**City of Charlottesville
Board of Architectural Review
Staff Summary
July 20, 2021**

Discussion of proposed stucco repairs

William Taylor Plaza – Phase I

(Currently the Fairfield Inn & Suites by Marriott Charlottesville Downtown/University Area)
401 Cherry Avenue

A-201

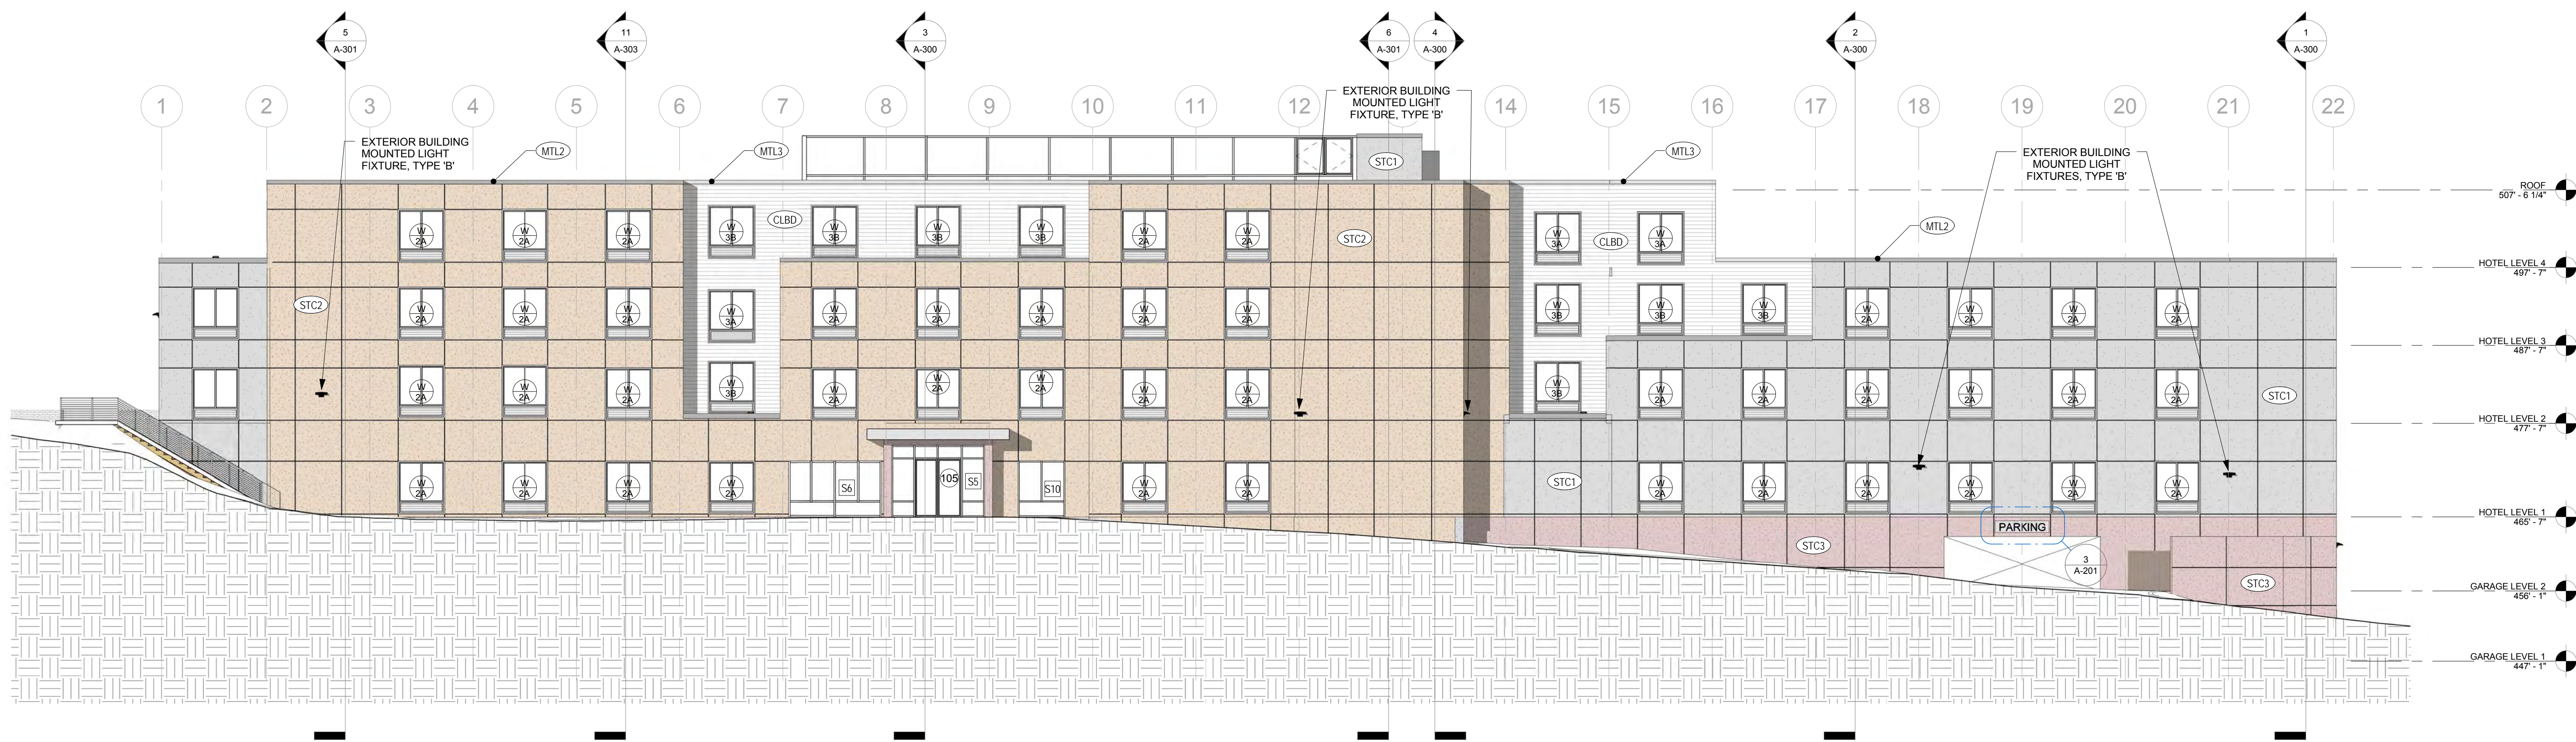
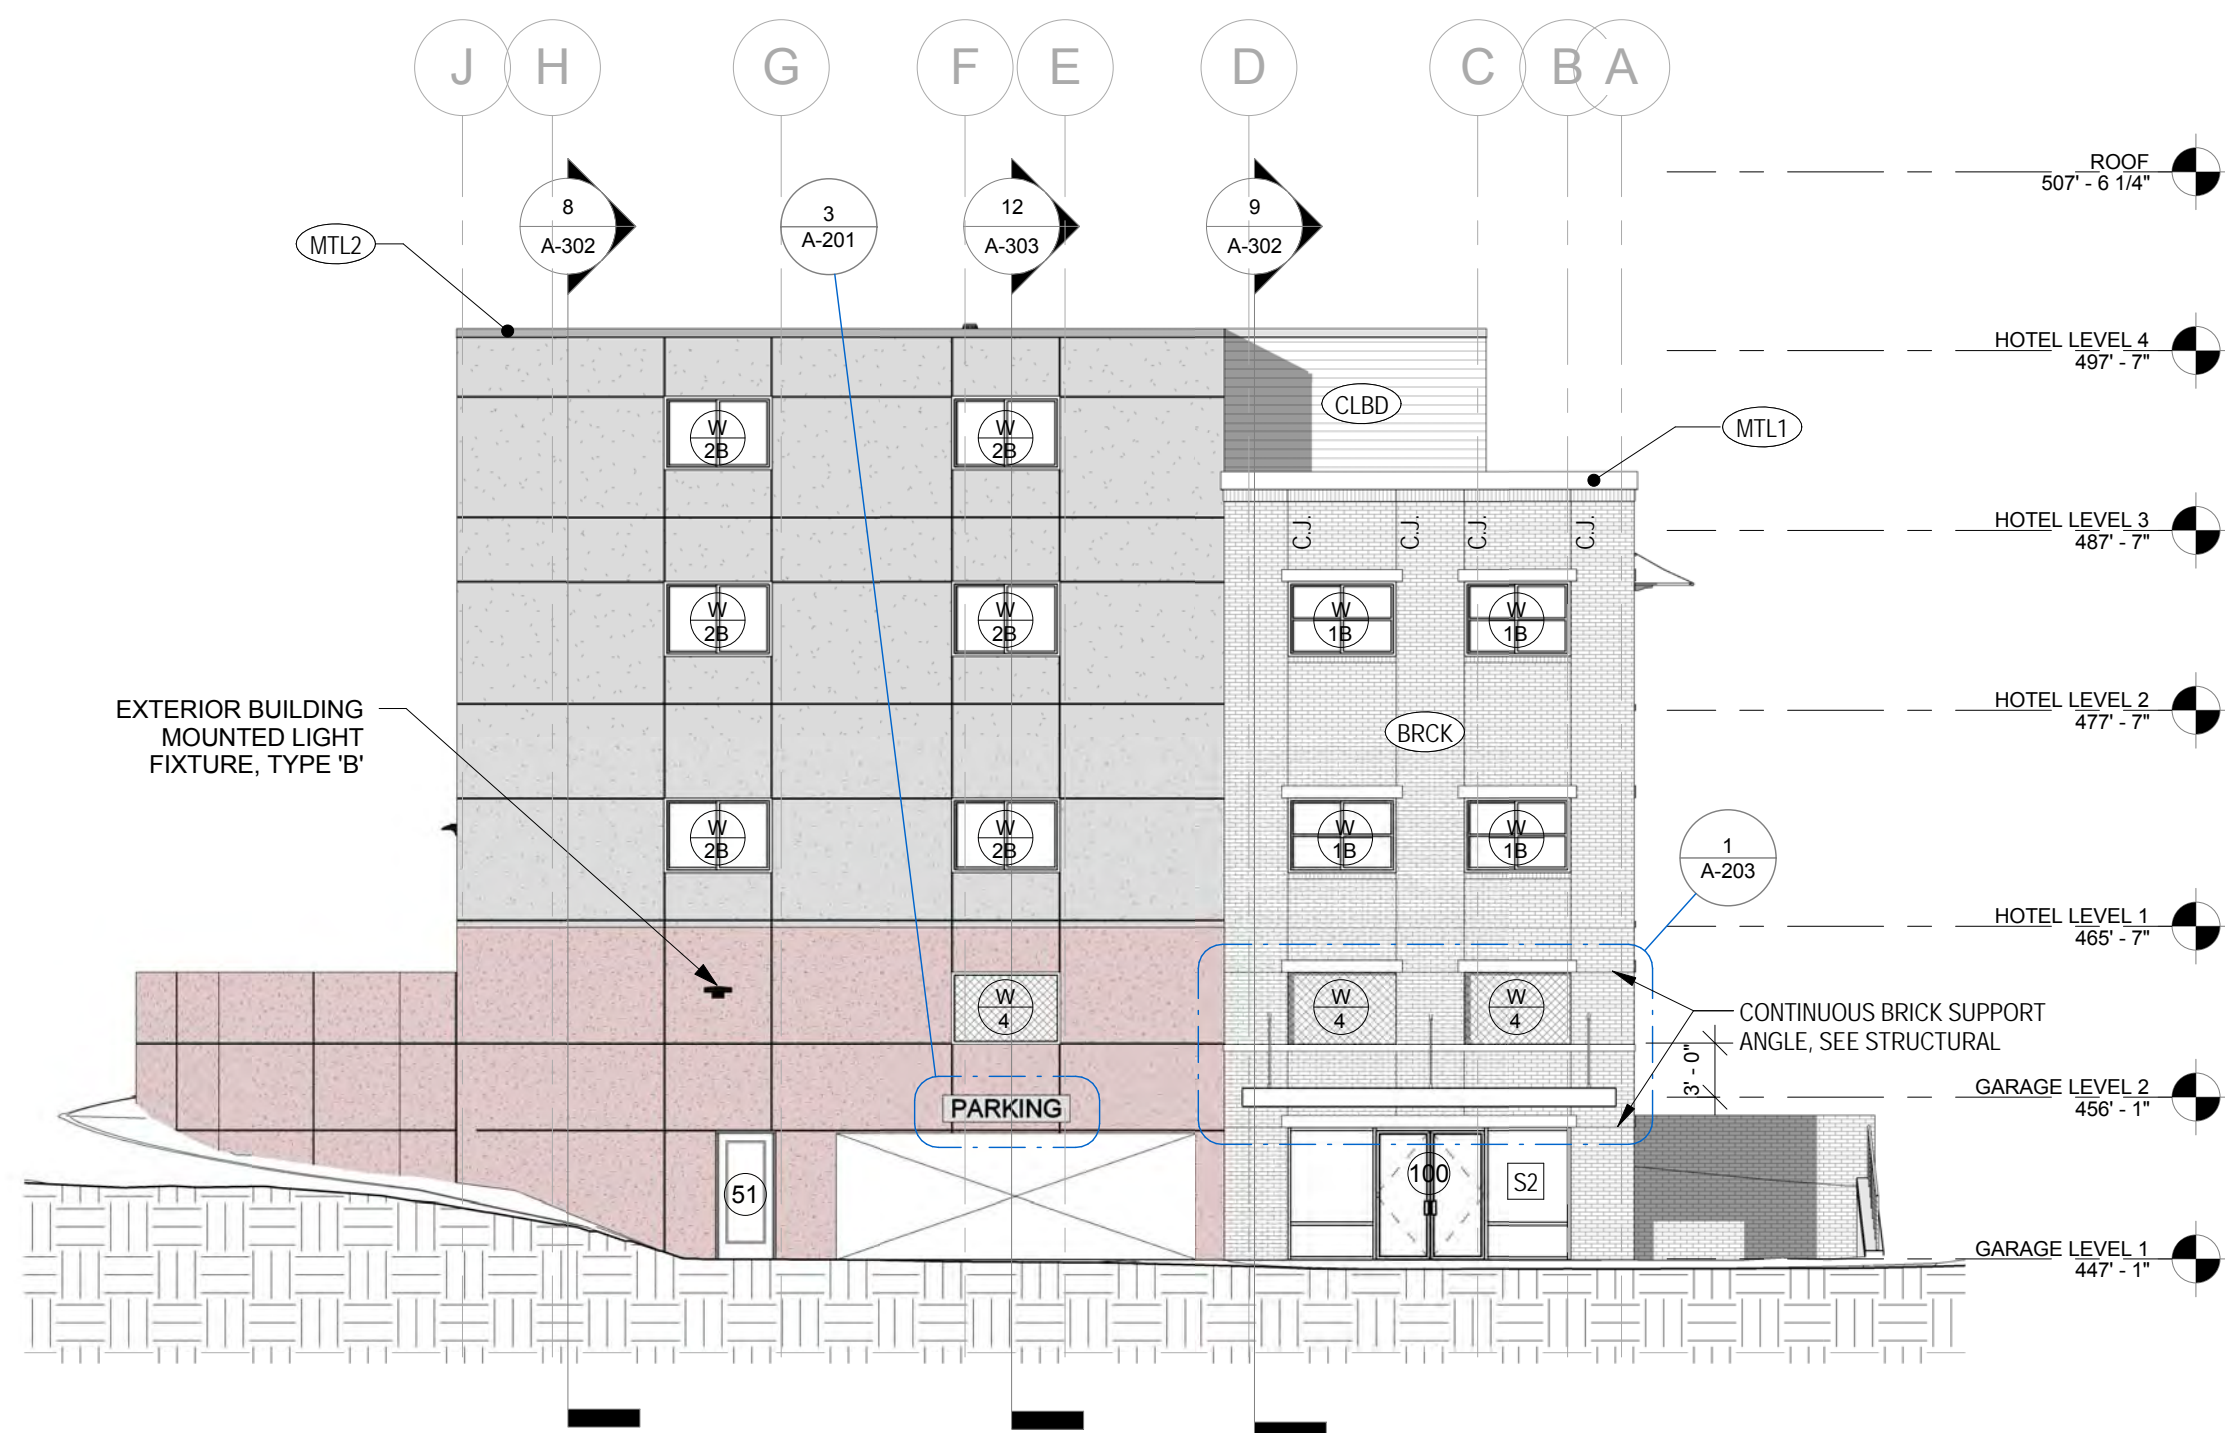
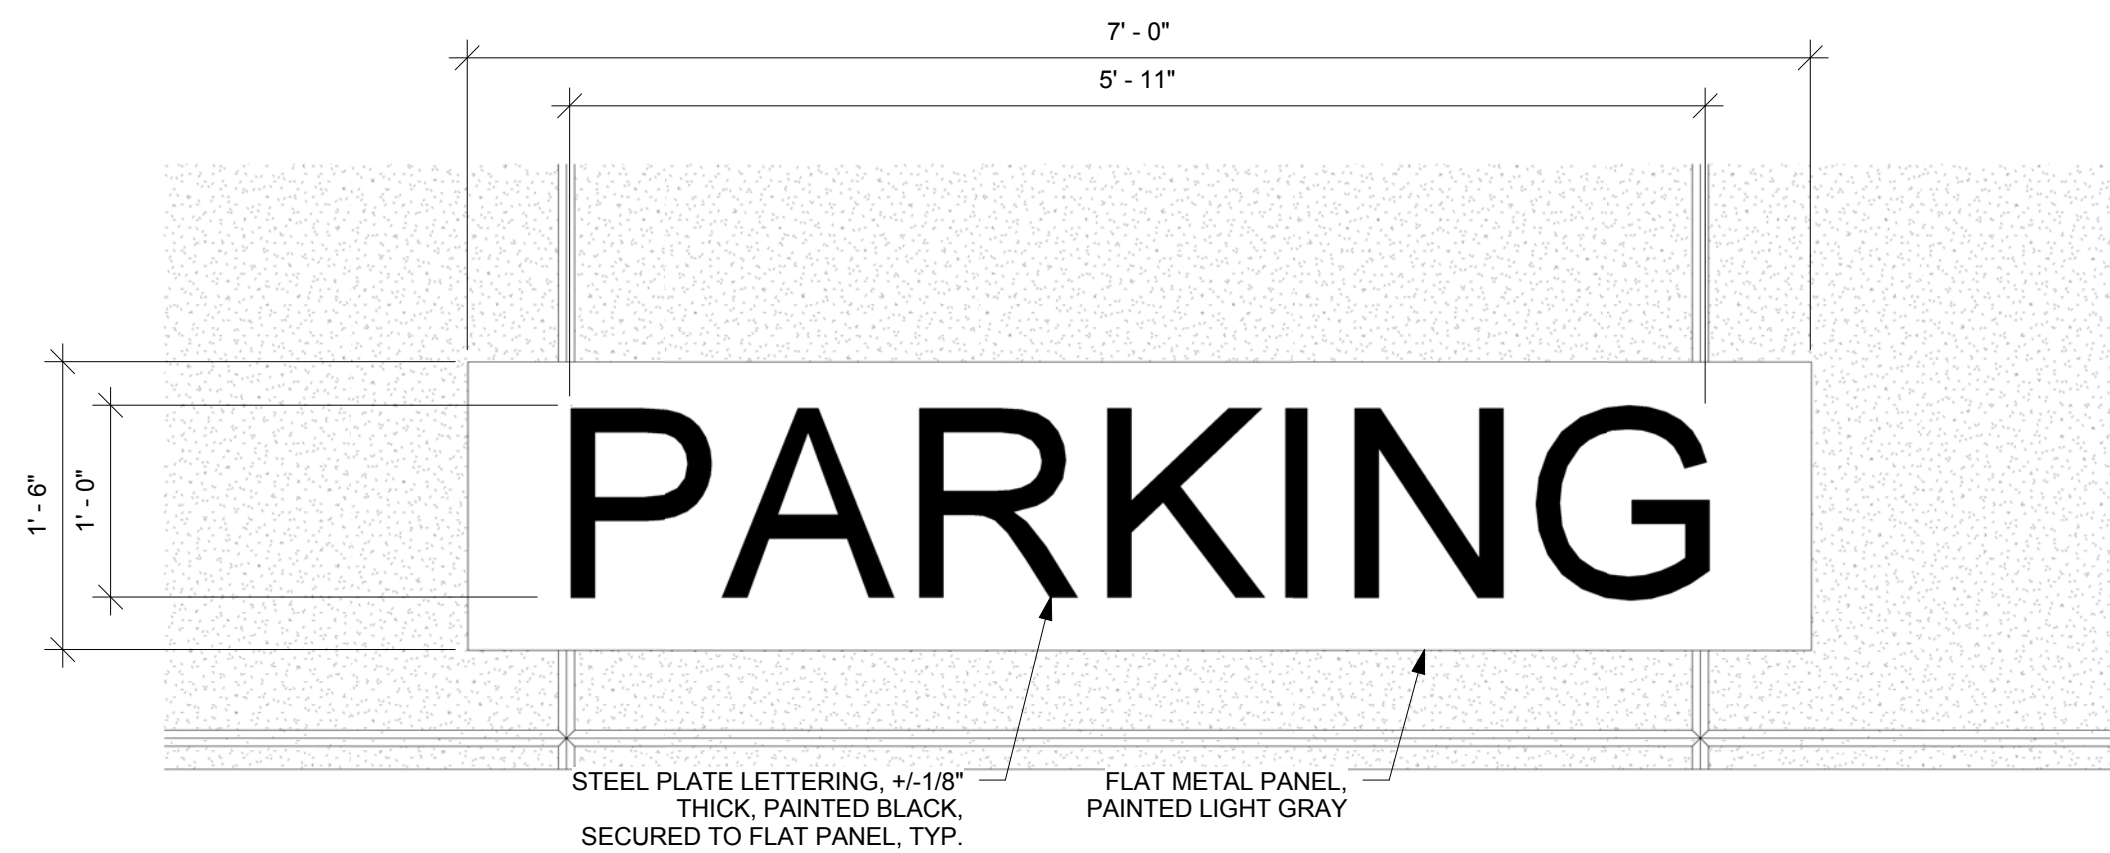
The areas to be repaired are all stucco walls shown on the elevations on sheets A-200 and A-201-- see the key in the lower, righthand corner. (Note: the clouded area on these sheets are not relevant. They are from modifications made in 2017, and not related to the stucco repair.)
